HISTORIC AND DESIGN REVIEW COMMISSION

HDRC CASE NO: 2021-580
ADDRESS: 434 SHERMAN ST
LEGAL DESCRIPTION: NCB 514 BLK 18 LOT E 75 FT OF 13
ZONING: R-6, H
CITY COUNCIL DIST.: 2
DISTRICT: Dignowity Hill Historic District
APPLICANT: robert amezquita/amezquita design studio
OWNER: Waseem Ali/ALI WASEEM & ZARRIELLO STEPHANIE
TYPE OF WORK: New construction
APPLICATION RECEIVED: November 02, 2021
60-DAY REVIEW: Not applicable due to City Council Emergency Orders
CASE MANAGER: Edward Hall
REQUEST:

The applicant is requesting a Certificate of Appropriateness for approval to construct a 1-story residential structure with a detached, rear accessory structure and a detached, rear carport at 434 Sherman.

A1.1

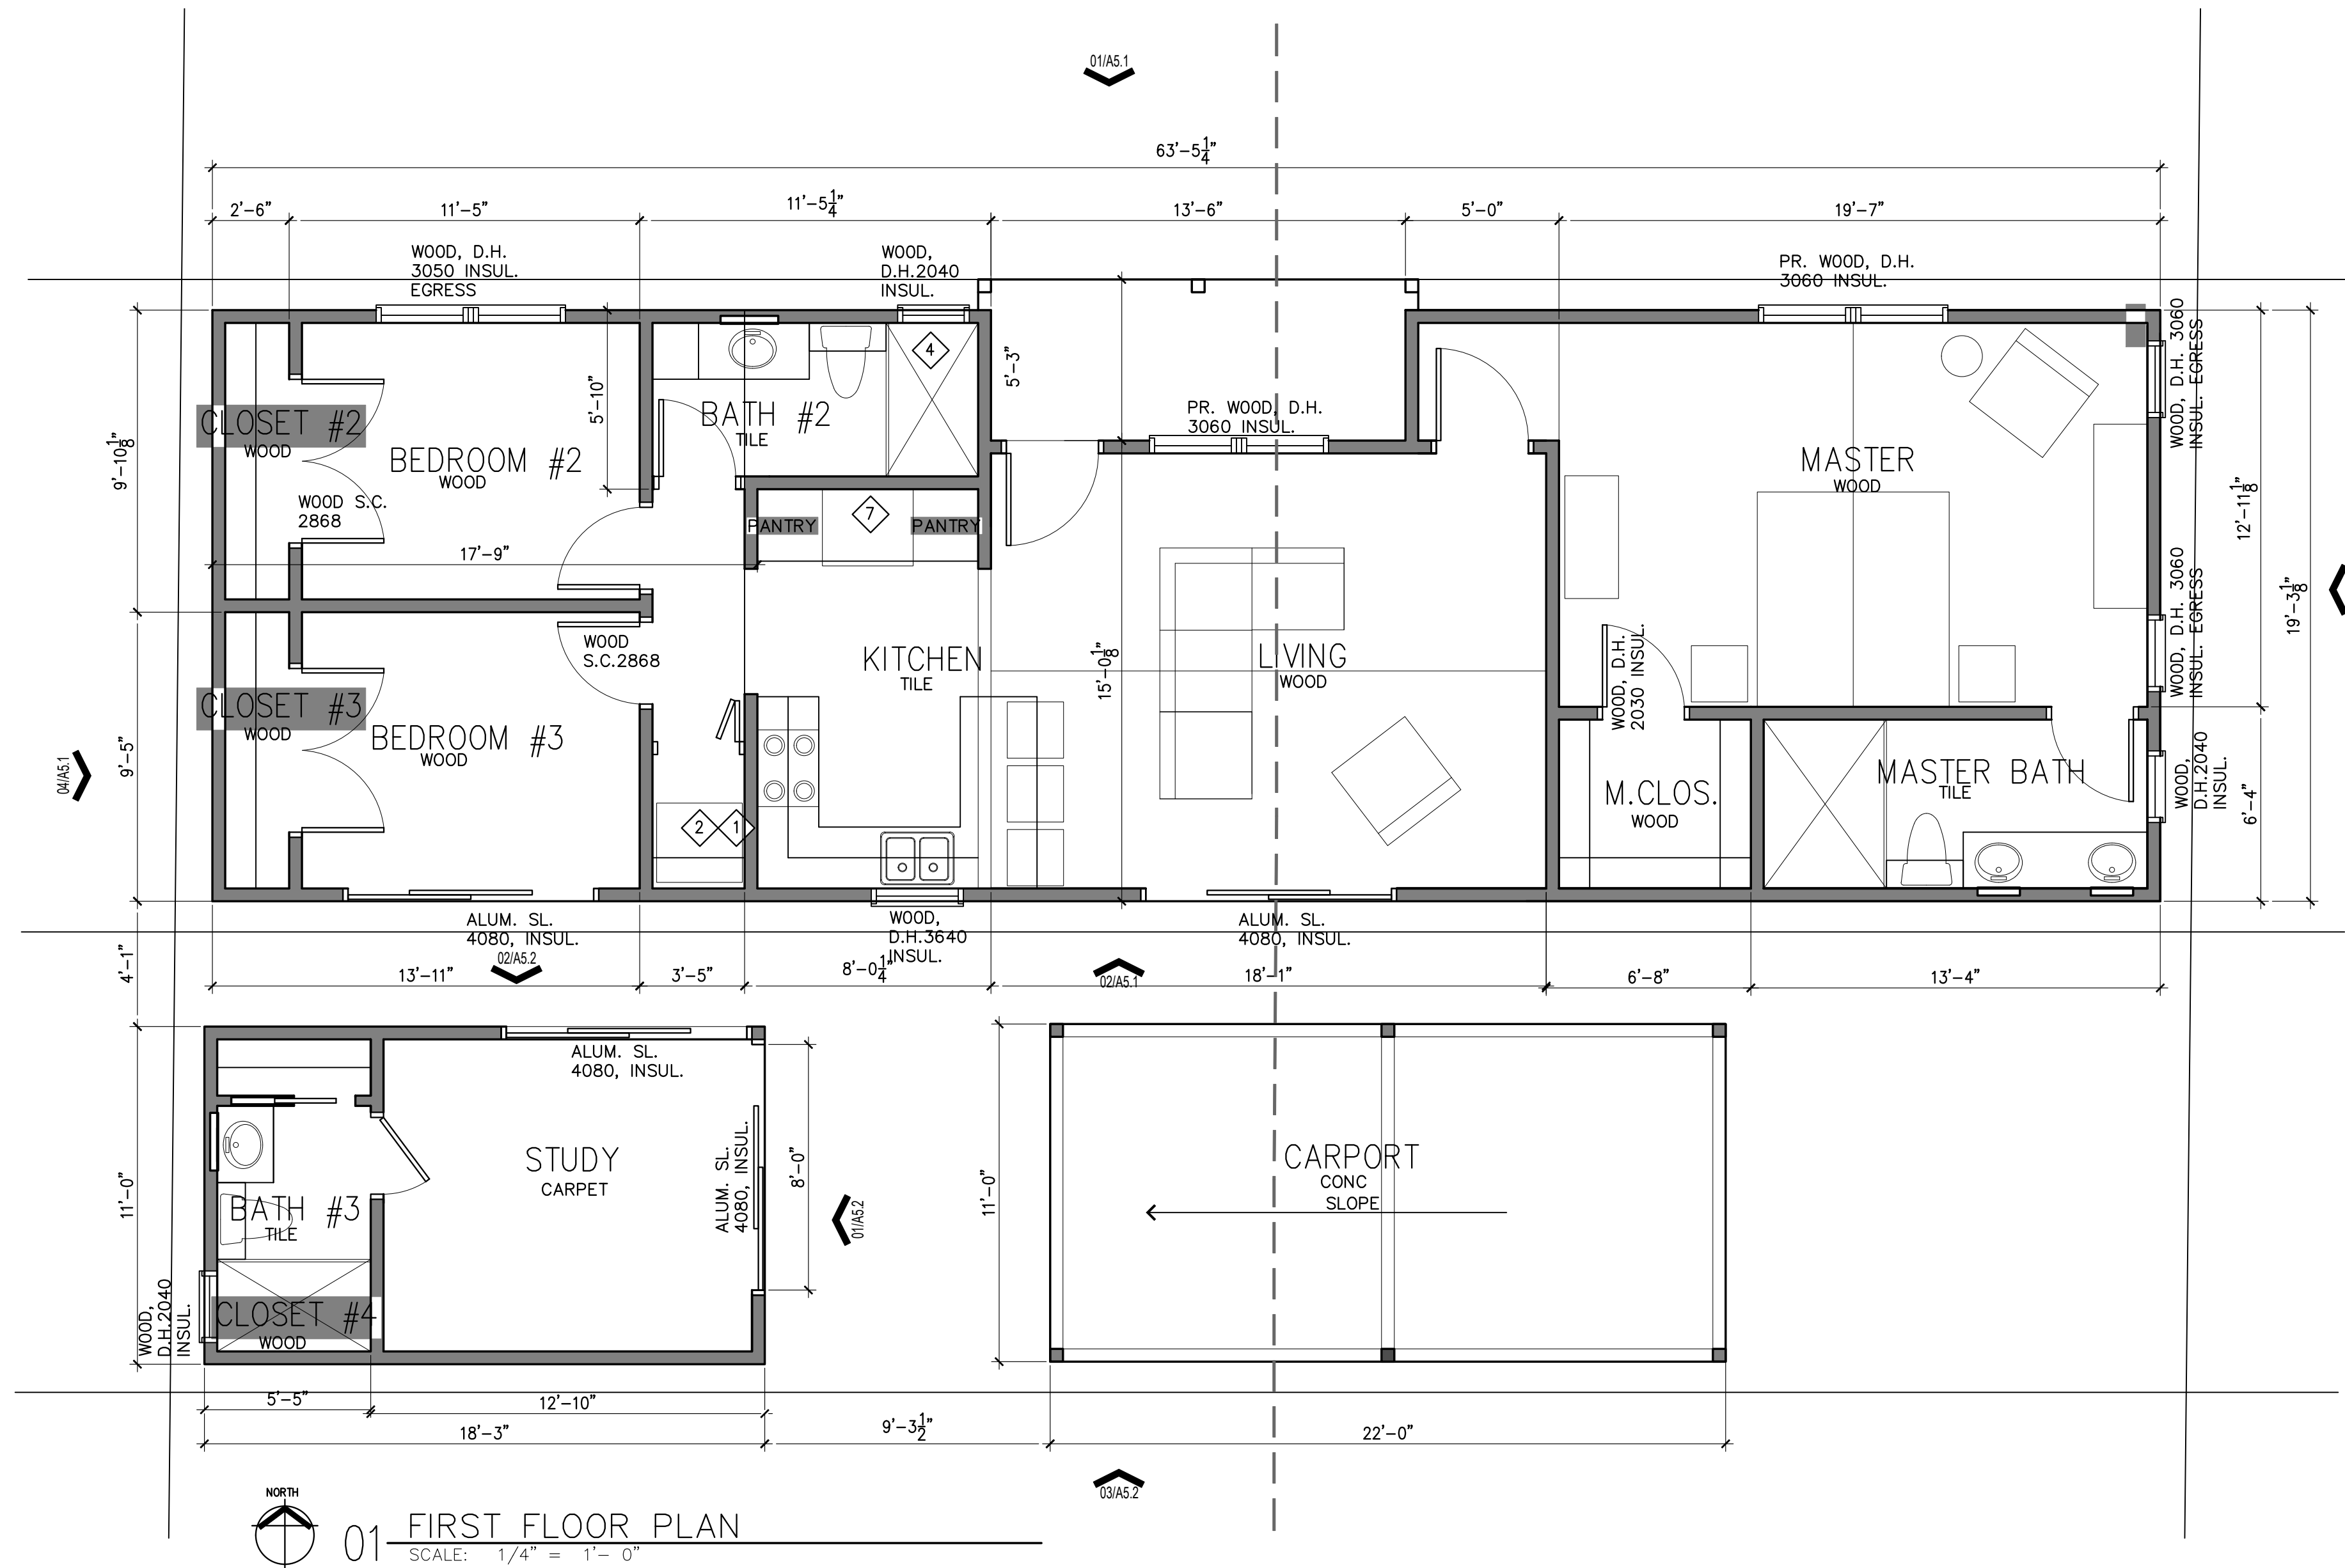
- m. FENESTRATION PROFILE – Generally, staff finds the proposed fenestration profile to be appropriate; however, staff finds that the applicant should add fenestration to the west façade, which is currently void of fenestration.

- q. DRIVEWAY – The applicant has proposed a driveway on N Olive of decomposed granite to feature a width of ten (10) feet. Generally, staff finds the proposed driveway to be appropriate.

- r. WALKWAY – The applicant has proposed a concrete walkway leading from the front porch of the proposed new construction to the right of way at Sherman. The proposed walkway will feature a width of four (4) feet and a

- iv. That fenestration be added to the west façade as noted in finding m.
- v. That no new chain-link fencing be installed on site.
- vi. That all mechanical equipment be screened from view from the public right of way as noted in finding t.

ROOF PLAN
A4.1

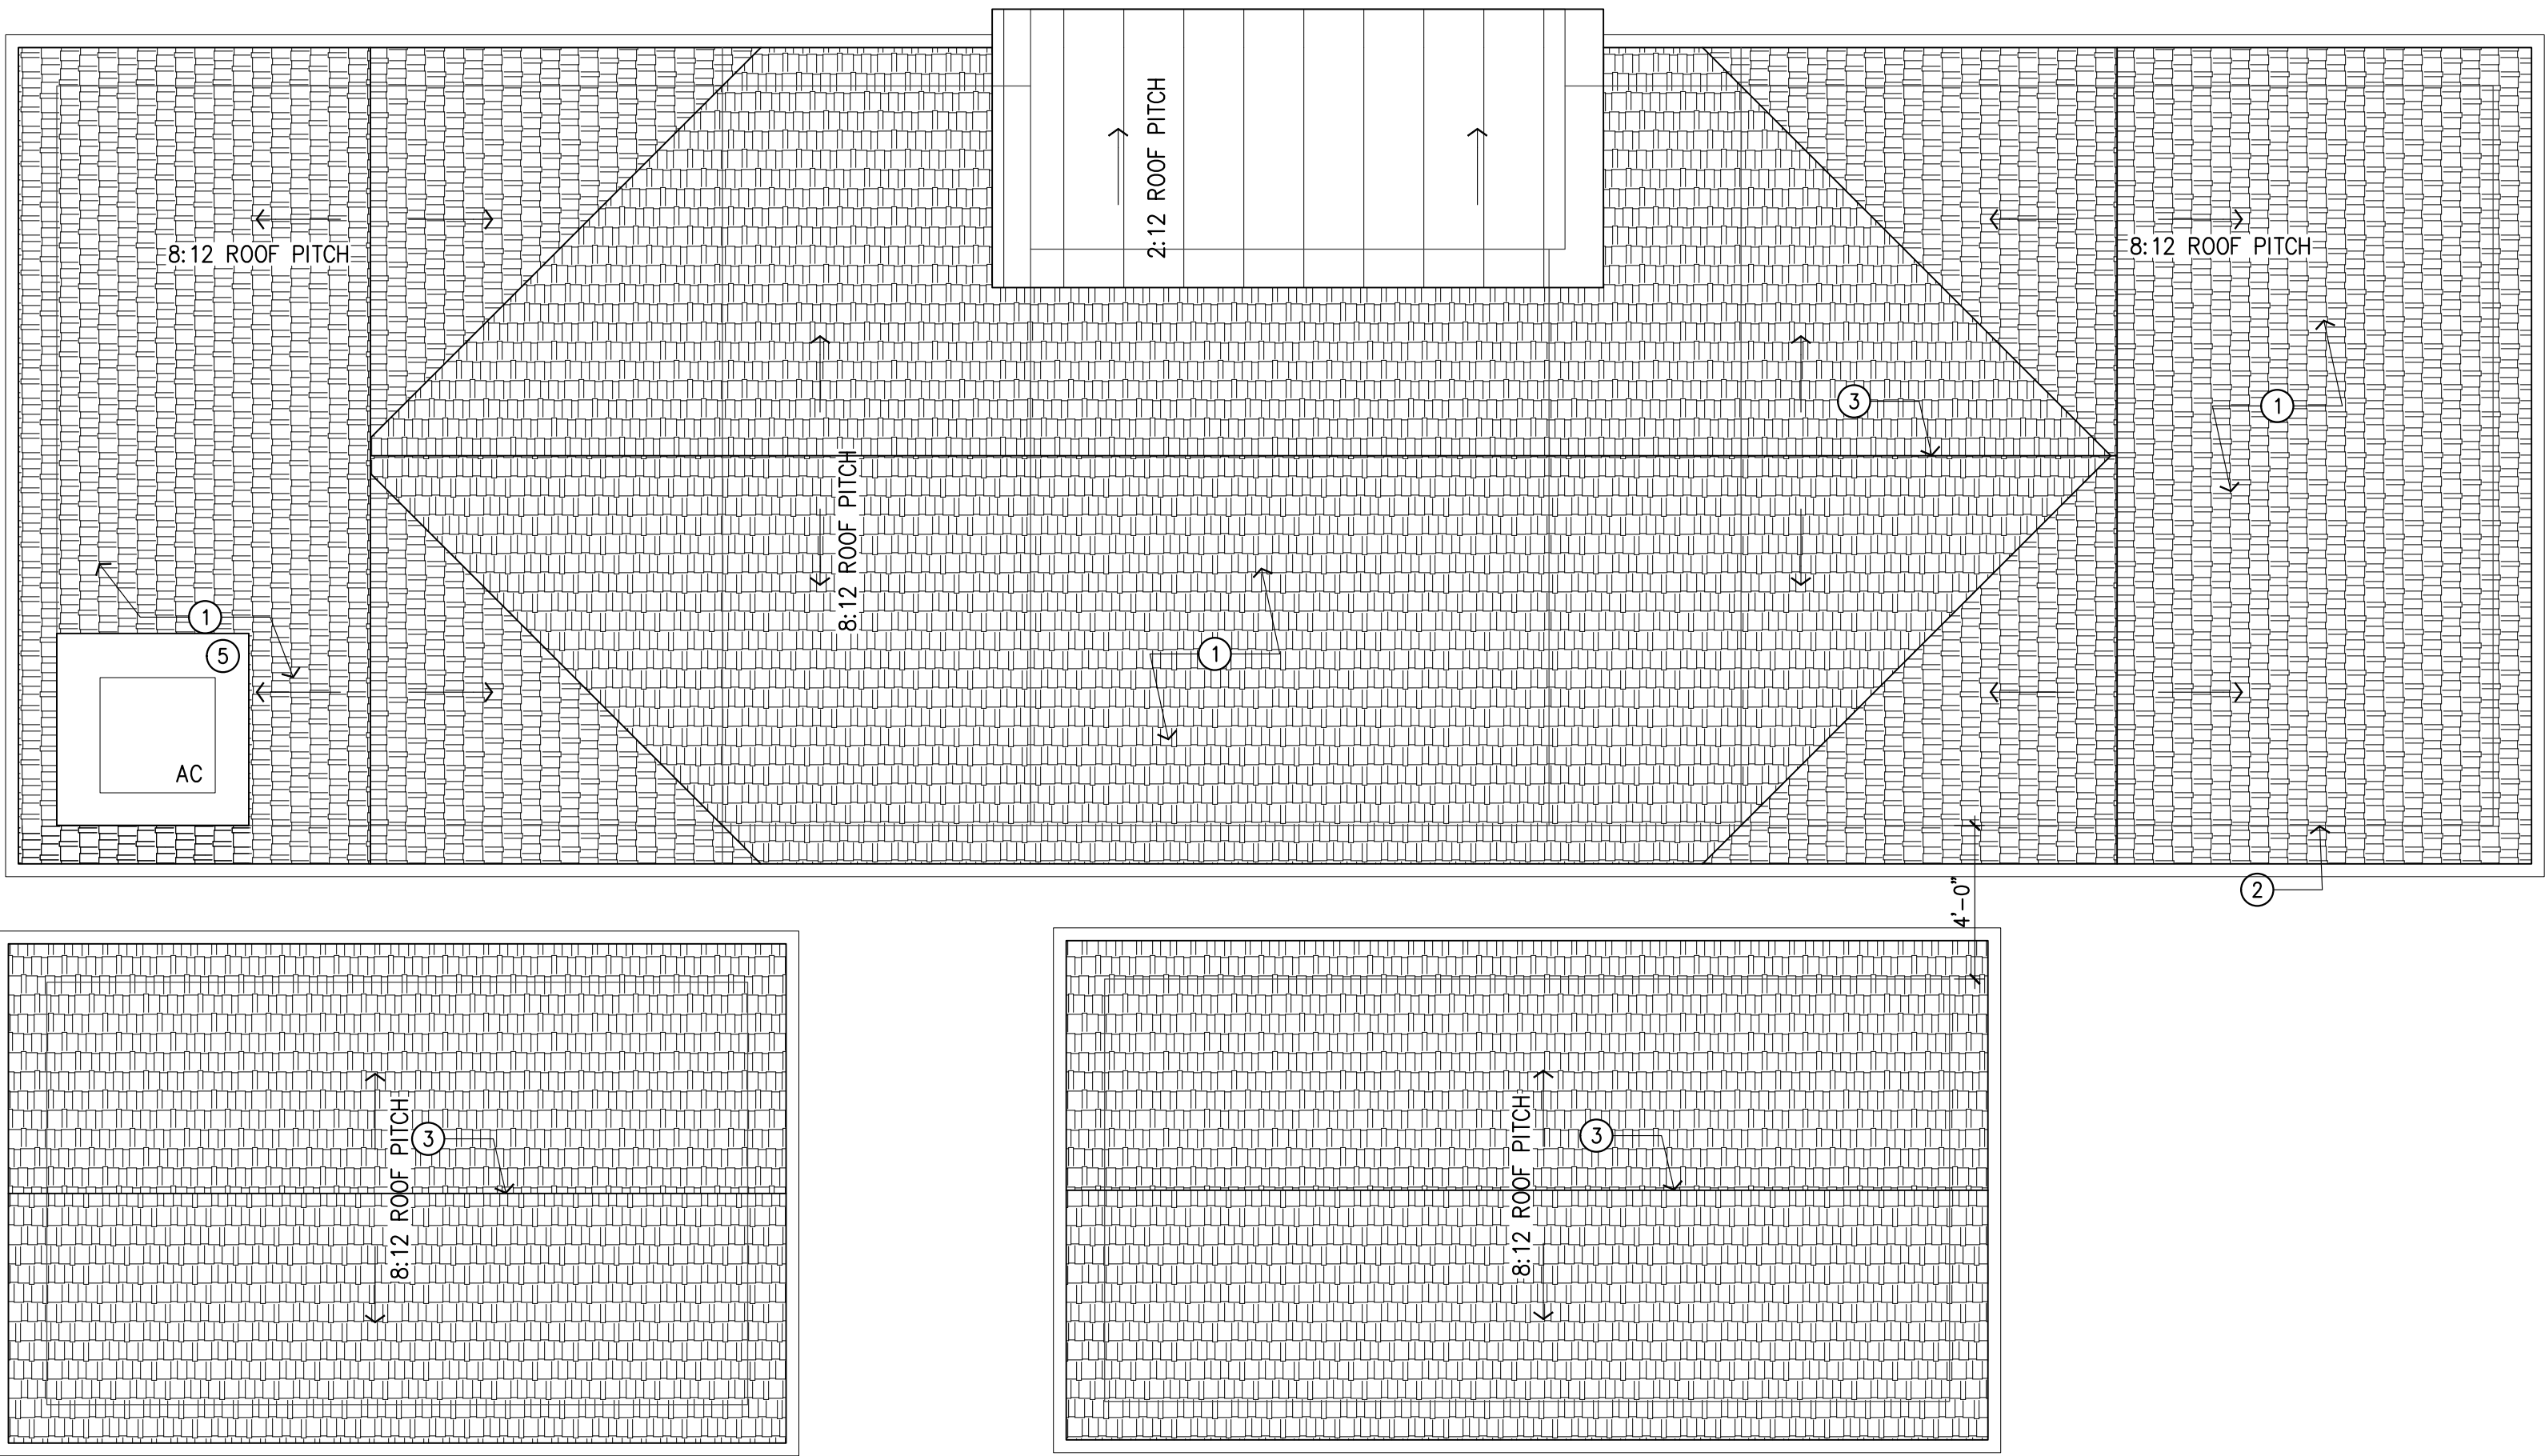
- i. ROOF FORM – The applicant has proposed for two front and rear facing gables to be connecting by a joining ridge. Generally, staff finds the proposed roof form to be appropriate and consistent with the Guidelines.
